Well Name: TAILS CC 10_3 FED COM	Well Location: T24S / R29E / SEC 15 / NWNE /	County or Parish/State:
Well Number: 38H	Type of Well: OIL WELL	Allottee or Tribe Name:
Lease Number: NMNM81616	Unit or CA Name:	Unit or CA Number:
US Well Number: 3001548877	Well Status: Approved Application for Permit to Drill	Operator: OXY USA INCORPORATED

Notice of Intent

Sundry ID: 2645772

Oxy USA Inc. - Tails CC 10_3 Federal Com 38H

Project: PRD NM DIRECTIONAL PLANS (NAD 1983)
 Site: Tails CC 10_3
 Well: Tails CC 10_3 Federal Com 38H
 Wellbore: Wellbore #1
 Design: Permitting Plan

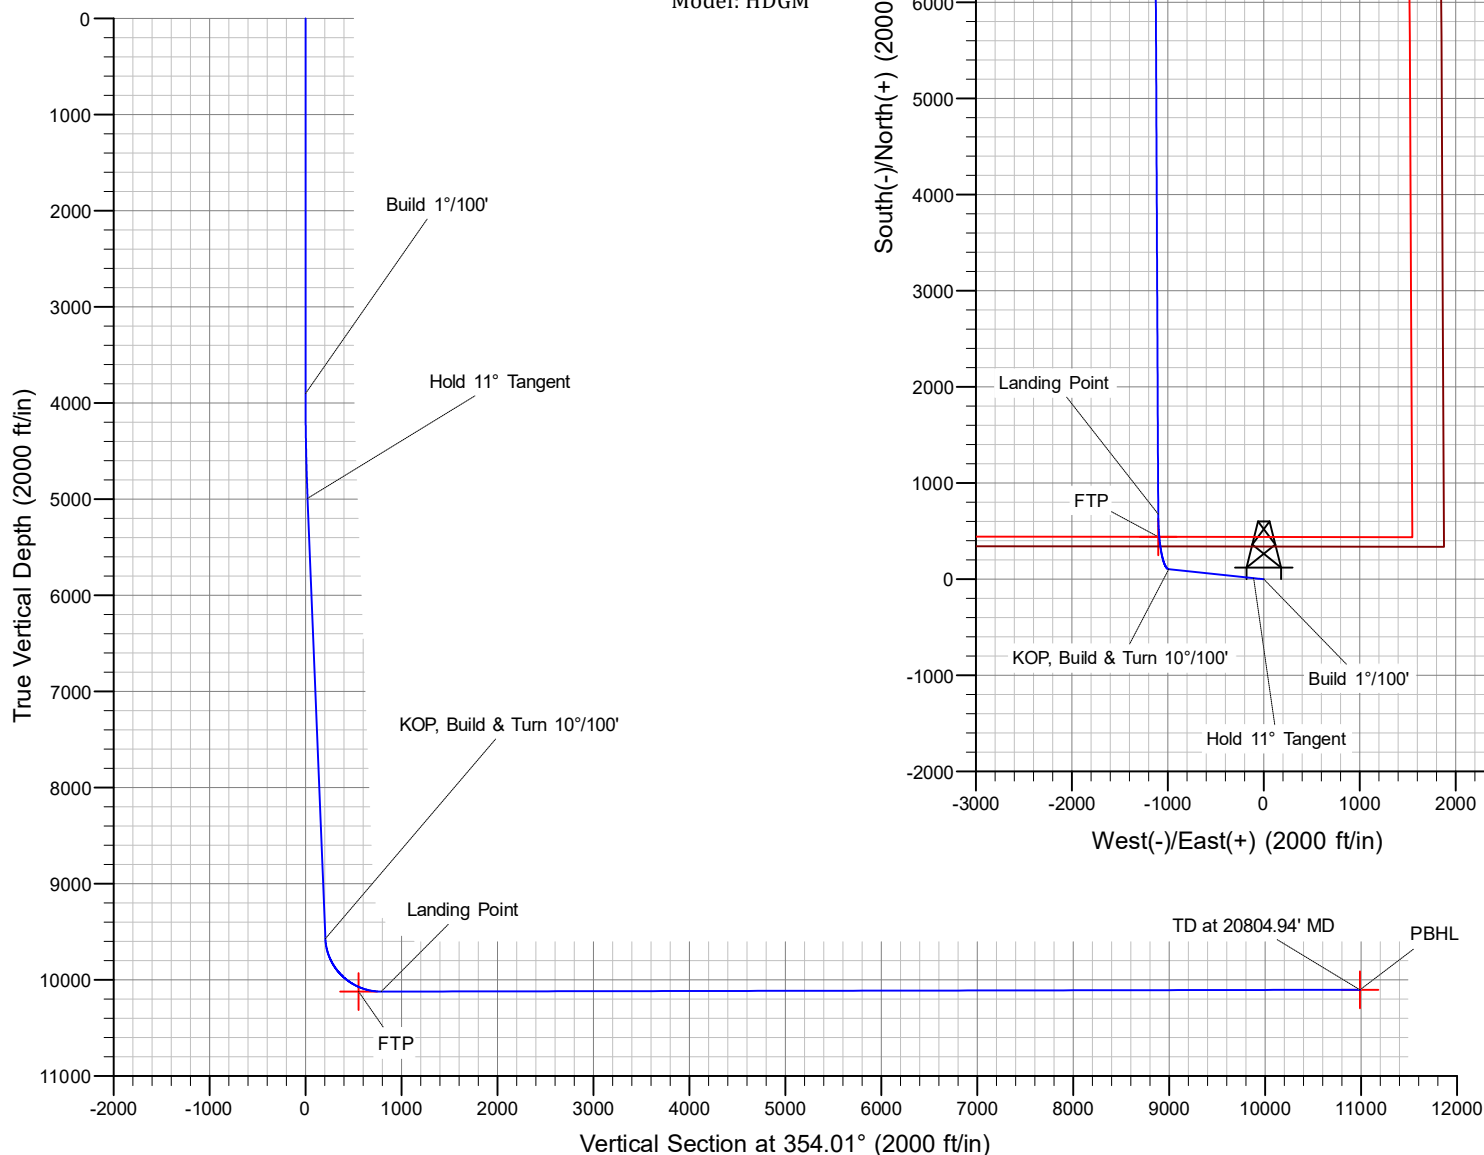
Procedure Description: OXY USA Inc. respectfully requests approved to amend the subject well AAPD well spacing and horizontal spacing unit to 1280-acres. Please see the attached C102 well plat, revised drill plan and directional for reference. The surface hole is not changing 12/17/21 5M BOPE updated as requested.
